**From:** [Pauli, Eric M](#)  
**To:** [Kearney, Darren](#); [Michele Nielson](#)  
**Subject:** RE: [EXT] EL15-004 Map Update  
**Date:** Thursday, September 21, 2023 10:29:05 AM  
**Attachments:** [image001.png](#)  
[image002.png](#)  
[image003.png](#)

Thought I would start with you on this. Touching base on a map update that Xcel Energy and Sioux Valley believe should be made in association with the territory boundary docket EL15-004 which was previously approved. If you look at the legal description produced below in Exhibit M, it does not appear to match what is on the SD PUC website. To further back this up, I am attaching a survey that was done (attached) in association with this area and more clearly identifying the section lines. If you could, please take a look at this and provide feedback as to how we might be able to get the map updated. Note that we don't believe any filing is needed but rather just an adjustment of the map since it appears to reflect the legal incorrectly.

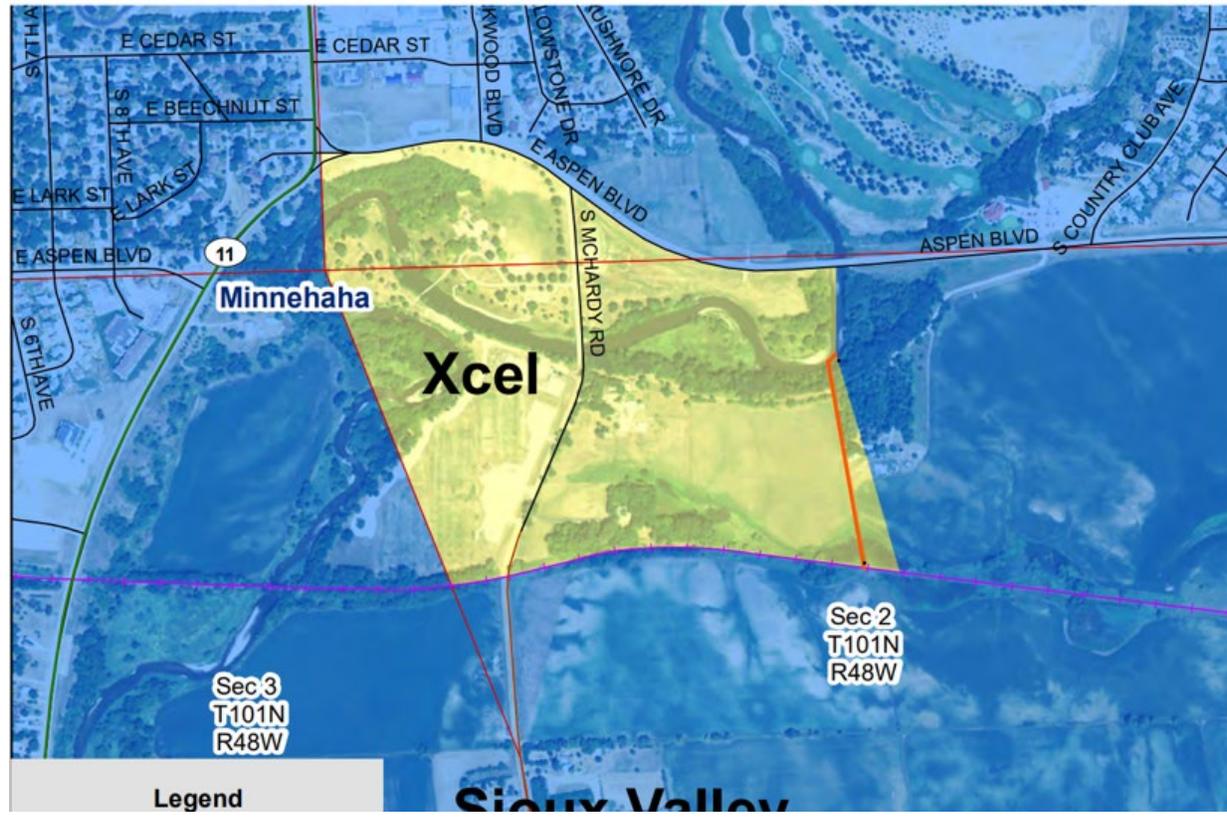
The west side is supposed to run along the section line. I don't think the Public Land Survey System section line reflects the slanted section line. Those section lines are odd in that area. Without a plat that I can match up to aerial imagery, I am hesitant to change the map. To me, Exhibit M from docket EL15-004 follows the section line shapefile that was used at that time. I haven't been able to find any better reference data.

As for your question on the west side, it appears that needs to be adjusted to when you look at the legal description on file. Would you agree Darren?

Is the red line below the edit you think that needs to be made based on the plat? Also, is there any edits needed on the west side?

I would be fine with that Darren.

I recommend just changing the area on the east side since it has now been platted and the west side can be adjusted in the future once it gets platted.

If Sioux Valley and Xcel both agree, I will go ahead and make the edit on the east side.
